Access Compliance Report

Public Rights-of-Way

(Curb Ramps)

Intersection ID: 48984	Main Street: ASHTON_GATE_DR	Cross Street: KINGSDOWN_AV	Location: SW
ADA ID: 030A182C95E5	Ramp Type: PerpDiag	Initial Pass/Fail: Fail	Overall Compliance: No
		Severity Score: 10

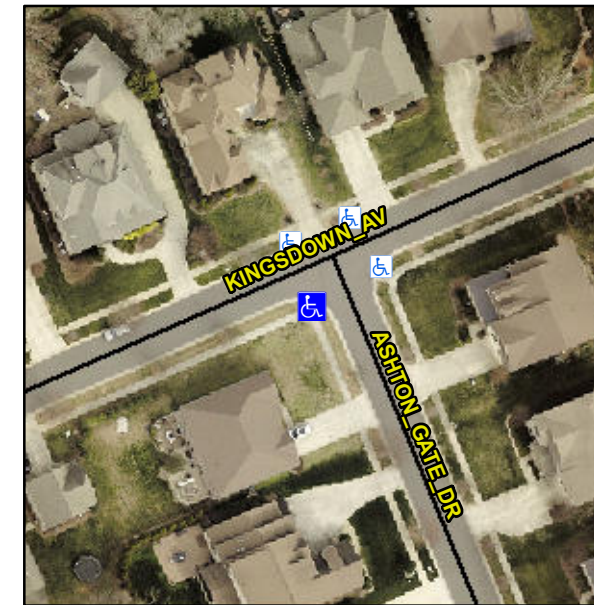
Not Found, R304.5.1, R304.5.3

Compliance	Description	Data	Compliance	Description	Data
N/A	Ramp Length (in)	70.0	Yes	Ramp Slope (%)	5.2
No	Ramp Width (in)	46.0	No	Ramp XSlope (%)	3.9
N/A	Flare Type LT	N/A	N/A	Flare Type RT	N/A
N/A	Flare Slope LT (%)	N/A	N/A	Flare Slope RT (%)	N/A
N/A	Flare Traversable LT?	N/A	N/A	Flare Traversable RT?	N/A
N/A	Landing Length (in)	N/A	N/A	DWS Provided?	N/A
N/A	Landing Width (in)	N/A	N/A	DWS Contrast?	N/A
N/A	Landing Slope (%)	N/A	N/A	DWS Length (in)	N/A
N/A	Landing X Slope (%)	N/A	N/A	DWS Full Width?	N/A
N/A	Landing Curb? (Y/N)	N/A	N/A	DWS Offset (in)	N/A
N/A	Shared Landing?	N/A			
N/A	Gutter Ponding?	N/A	N/A	Gutter Slope (%)	N/A
N/A	Gutter Lip Ht (in)	N/A	N/A	Gutter X Slope (%)	N/A
N/A	Painted X Walk1?	No	N/A	Painted X Walk2?	No
	X Walk 1 Direction	To E		X Walk 2 Direction	To N
N/A	X Walk 1 Width (in)	N/A	N/A	X Walk 2 Width (in)	N/A
	X Walk 1 Slope (%)	0.9		X Walk 2 Slope (%)	5.4
	X Walk 1 X Slope (%)	3.7		X Walk 2 X Slope (%)	1.8

Remove & Replace Curb Ramp With Two New Directional Ramps or Equivalent.
